COMPARISON - AS GRANTED SCHEME X EXISTING SCHEME

RETENTION

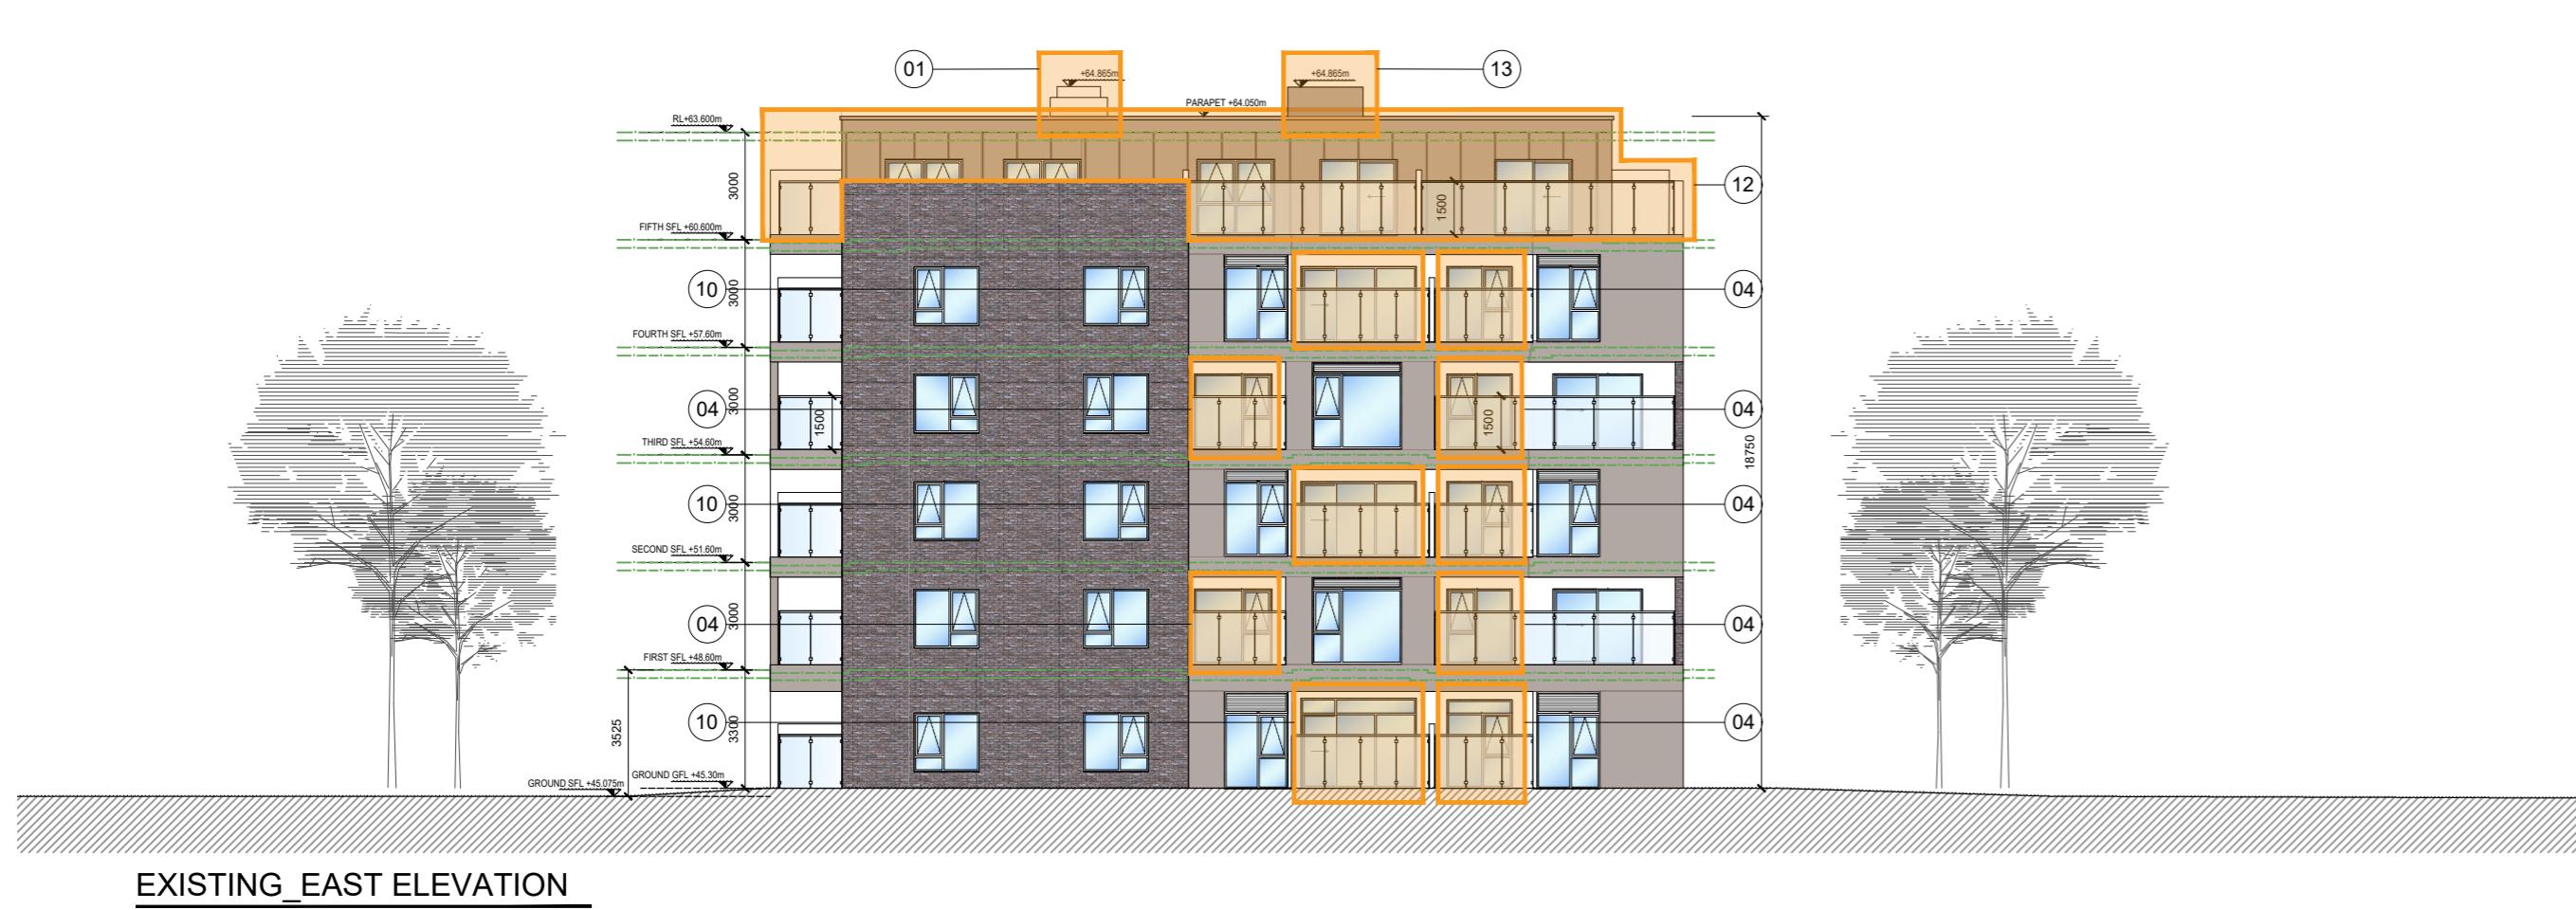
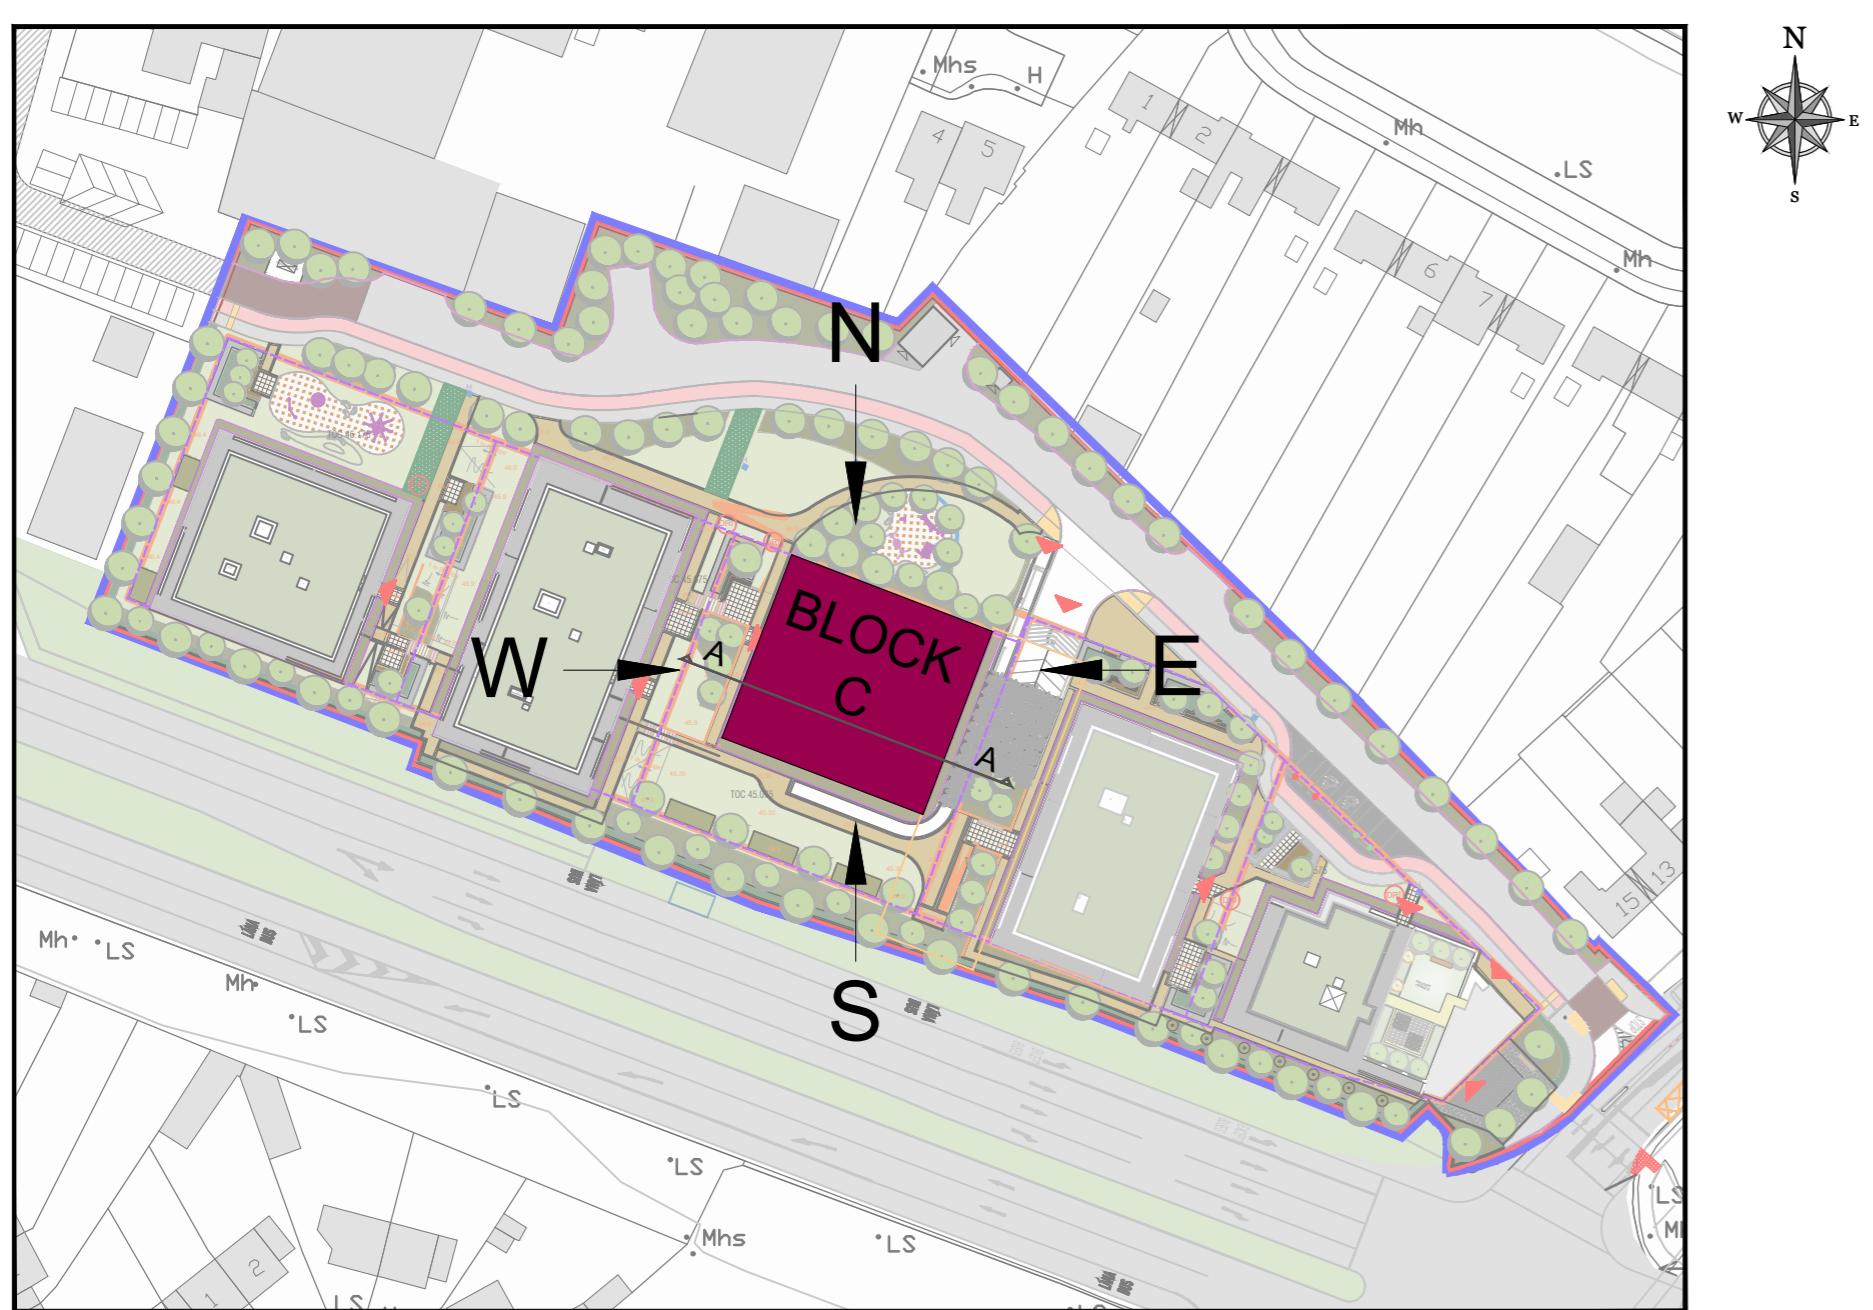
- 01 - AS GRANTED: SIMPLE ACCESS TO THE UNITS;
EXISTING: THE CORRIDOR LAYOUT HAS BEEN RECONFIGURED DUE TO THE INCLUSION OF AOV;
- 02 - AS GRANTED: PROVISION ONE WINDOW FOR THE LIVING AREA;
EXISTING: A NEW WINDOW WAS BUILT DUE TO A CHANGE IN THE KITCHEN LAYOUT;

- 03 - AS GRANTED: PROVISION OF A TRIPLE SLIDING DOOR;
EXISTING: A DOUBLE SLIDING DOOR WAS BUILT;
- 04 - AS GRANTED: PROVISION OF A DOUBLE SLIDING DOOR;
EXISTING: A DOUBLE OPENING WINDOW WAS BUILT;

- 05 - AS GRANTED: OPENING THE ACCESS DOOR FROM THE RIGHT;
EXISTING: MAIN ACCESS DOOR OPENING CHANGED TO THE LEFT;
- 06 - AS GRANTED: PROVISION OF A DOUBLE SLIDING DOOR;
EXISTING: A SINGLE OPENING WINDOW WAS BUILT;

- 07 - AS GRANTED: NO ACCESS TO OPEN SPACE;
EXISTING: A SINGLE DOOR WAS BUILT TO ACCESS THE NEW BALCONY;
- 08 - AS GRANTED: PROVISION OF A WINDOW;
EXISTING: A DOOR WAS BUILT TO ACCESS THE BALCONY;

- 09 - AS GRANTED: PROVISION OF A DOUBLE SLIDING DOOR;
EXISTING: A DOUBLE OPENING WINDOW WAS BUILT;
- 10 - AS GRANTED: PROVISION OF A DOUBLE SLIDING DOOR;
EXISTING: A TRIPLE SLIDING DOOR WAS BUILT INCREASING THE DIMENSIONS OF THE OPENING;

- 11 - AS GRANTED: PROVISION OF A DOUBLE SLIDING DOOR;
EXISTING: LARGER DOUBLE SLIDING DOOR WAS BUILT;
- 12 - AS GRANTED: PROVISION OF WINDOW AND DOOR OPENINGS FOR A PENTHOUSE LAYOUT FOR 3 No. 2-BEDS UNITS AND 4 No. 1-BED

UNITS;
EXISTING: LAYOUT HAS BEEN RECONFIGURED TO A PENTHOUSE WITH 1 No. 2-BEDS UNIT AND 6 No. 1-BED UNITS SO ALL THE WINDOW AND DOOR OPENINGS WERE BUILT IN DIFFERENT POSITIONS OR DIMENSIONS;
13 - AS GRANTED: THE PREVIOUSLY APPROVED LIFT DIDN'T INCLUDE AN ENGINE ROOM;
EXISTING: THE LIFT ENGINE ROOM WAS BUILT ACCORDING TO THE MANUFACTURER'S SPECIFICATIONS, CHANGING THE DESIGN SEEN IN THE ROOF PLAN AND ELEVATION;
